Modification Recommended Service Note

E1466A 4x64 Relay Matrix Switch

E1466A may fail to open/close relays because of a defective relay driver IC with date code 0325.

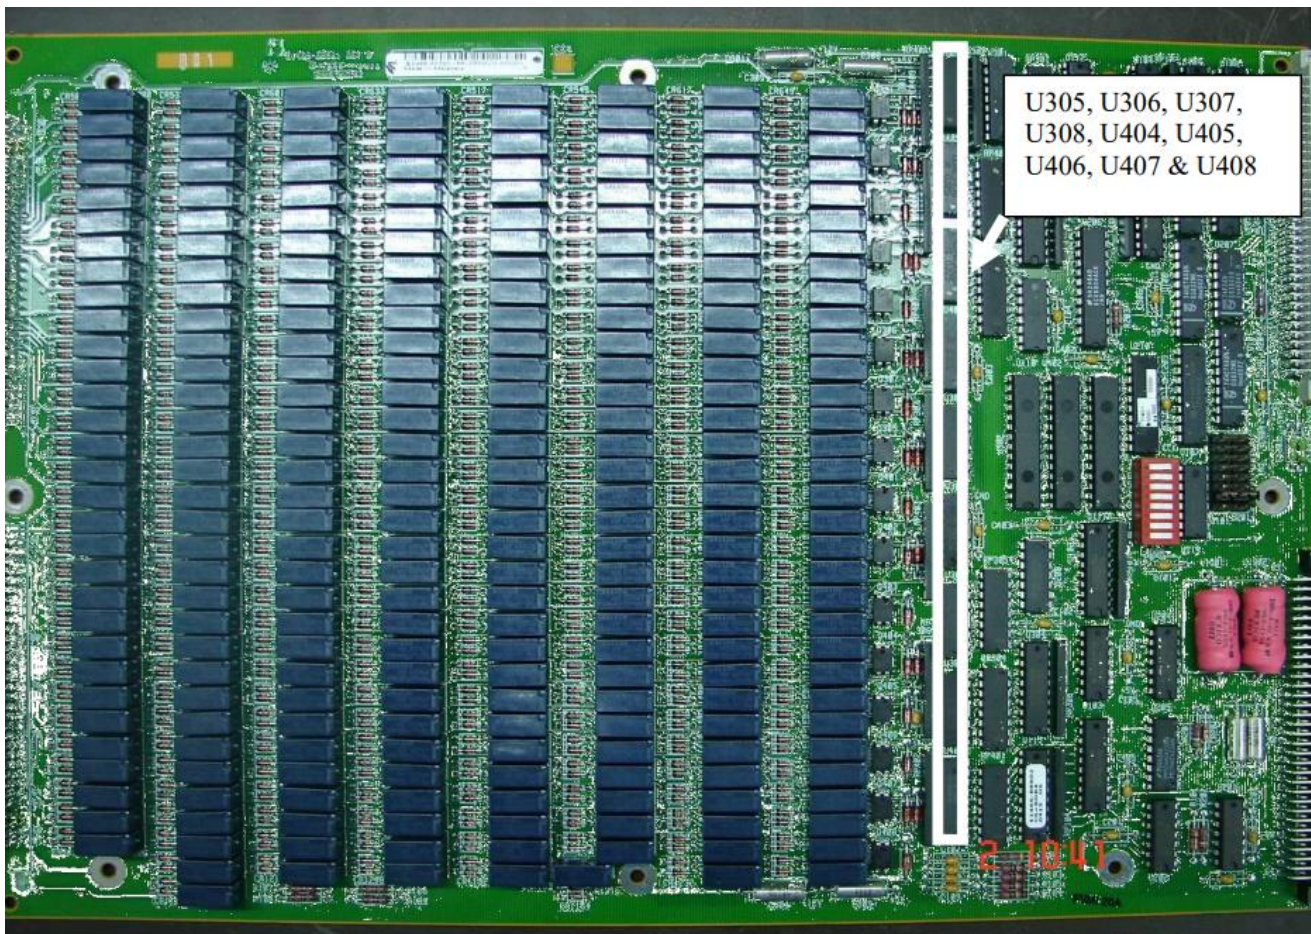
The relay driver ICs are U305, U306, U307, U308, U404, U405, U406, U407, and U408 which are the LTB part 5188-2550 for 1820-4599.

The bad date code is 0325. This date code has a much higher failure rate. Most failures have occurred in the first three months of usage. See the following pictures for part and date code location.

Part Number : E1466-66501
Location Impacted : U305, U306, U307, U308, U404, U405, U406, U407, and U408

Reject Criteria : DC 0325 on IC

A E1466A that fails to close or open its relays and has the 0325 date code ICs should be replaced with a E1466-66701 or E1466-69701.
